# Transport and Environment Committee

## Picardy Place Island, Public Realm Improvement Project

**Picardy Place Central Island**  
Stakeholder Engagement You Said, We Did

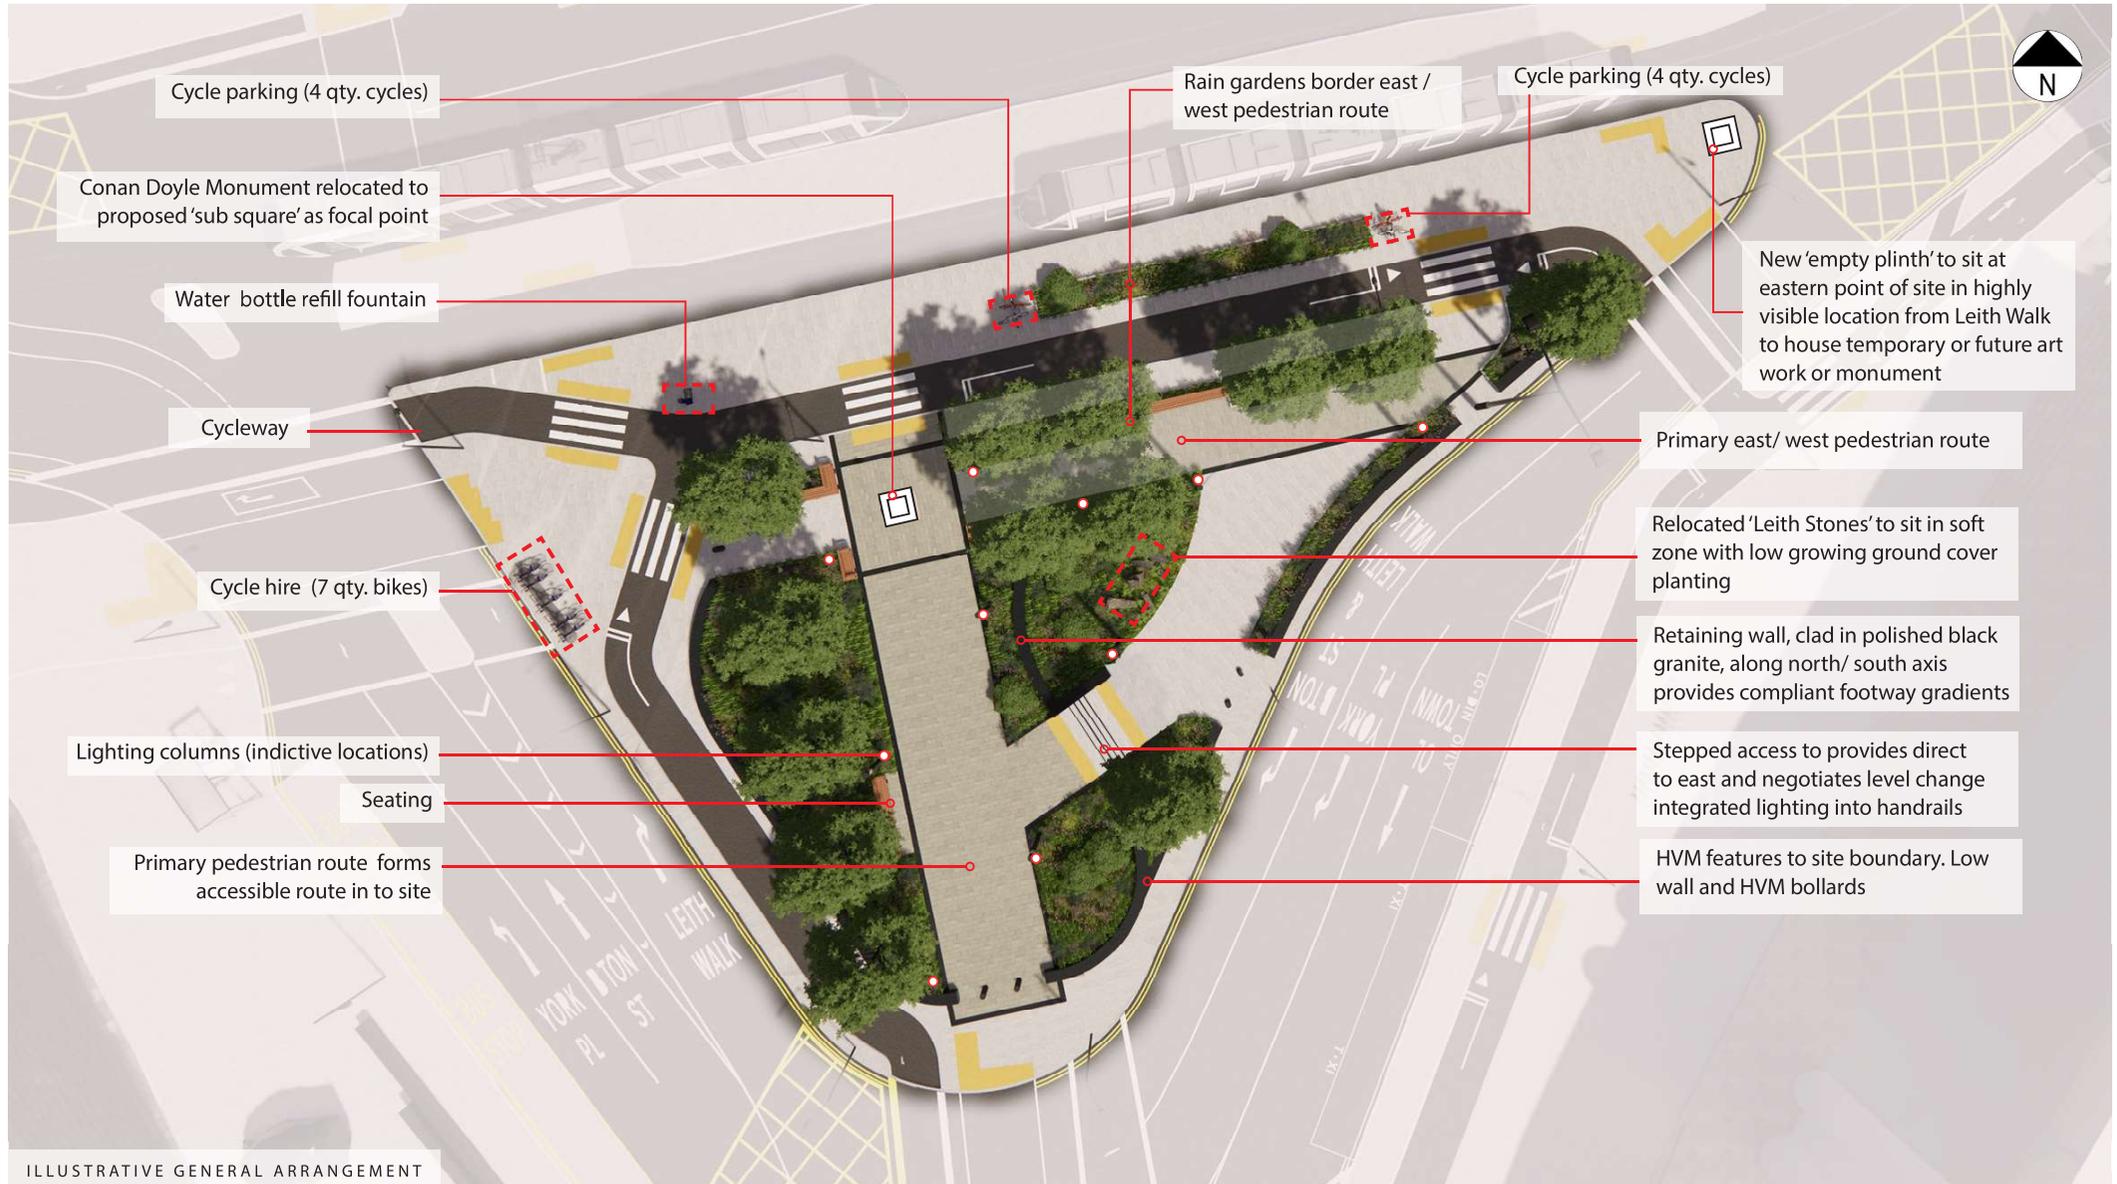
- These should not be pedestrian obstructions.

- A continuous HVM line is required to provide protection to the site interior. The HVM measures are in the form of low walls where no pedestrian access is required and bollards where pedestrian access/ egress is required.
